# Access Compliance Report

## Public Rights-of-Way

Intersection ID: 45834	Main Street: PATRICIA ANN LN	Cross Street: KELDEN WALKER LN	Location: E
ADA ID: D27268D5507D	Ramp Type: PerpDiag	Initial Pass/Fail: Fail	Overall Compliance: No
Severity Score: 30			
Codes/Mitigation Info/Possible Solution		Field Measurements/Component Compliance

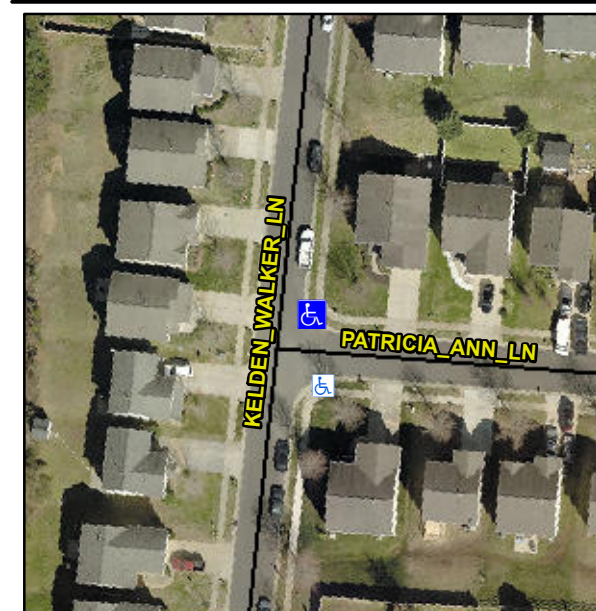
**Not Found, R304.5.1, R304.2.2**

Compliance	Description	Data	Compliance	Description	Data
N/A	Ramp Length (in)	48.0	No	Ramp Slope (%)	8.6
No	Ramp Width (in)	32.5	Yes	Ramp XSlope (%)	1.9
N/A	Flare Type LT	N/A	N/A	Flare Type RT	N/A
N/A	Flare Slope LT (%)	N/A	N/A	Flare Slope RT (%)	N/A
N/A	Flare Traversable LT?	N/A	N/A	Flare Traversable RT?	N/A
N/A	Landing Length (in)	N/A	N/A	DWS Provided?	N/A
N/A	Landing Width (in)	N/A	N/A	DWS Contrast?	N/A
N/A	Landing Slope (%)	N/A	N/A	DWS Length (in)	N/A
N/A	Landing X Slope (%)	N/A	N/A	DWS Full Width?	N/A
N/A	Landing Curb? (Y/N)	N/A	N/A	DWS Offset (in)	N/A
N/A	Shared Landing?	N/A			
N/A	Gutter Ponding?	N/A	N/A	Gutter Slope (%)	N/A
N/A	Gutter Lip Ht (in)	N/A	N/A	Gutter X Slope (%)	N/A
N/A	Painted X Walk1?	No	N/A	Painted X Walk2?	No
	X Walk 1 Direction	To W		X Walk 2 Direction	To S
N/A	X Walk 1 Width (in)	N/A	N/A	X Walk 2 Width (in)	N/A
	X Walk 1 Slope (%)	0.6		X Walk 2 Slope (%)	4.1
	X Walk 1 X Slope (%)	4.0		X Walk 2 X Slope (%)	1.9

**Remove & Replace Curb Ramp With Two New Directional Ramps or Equivalent.**
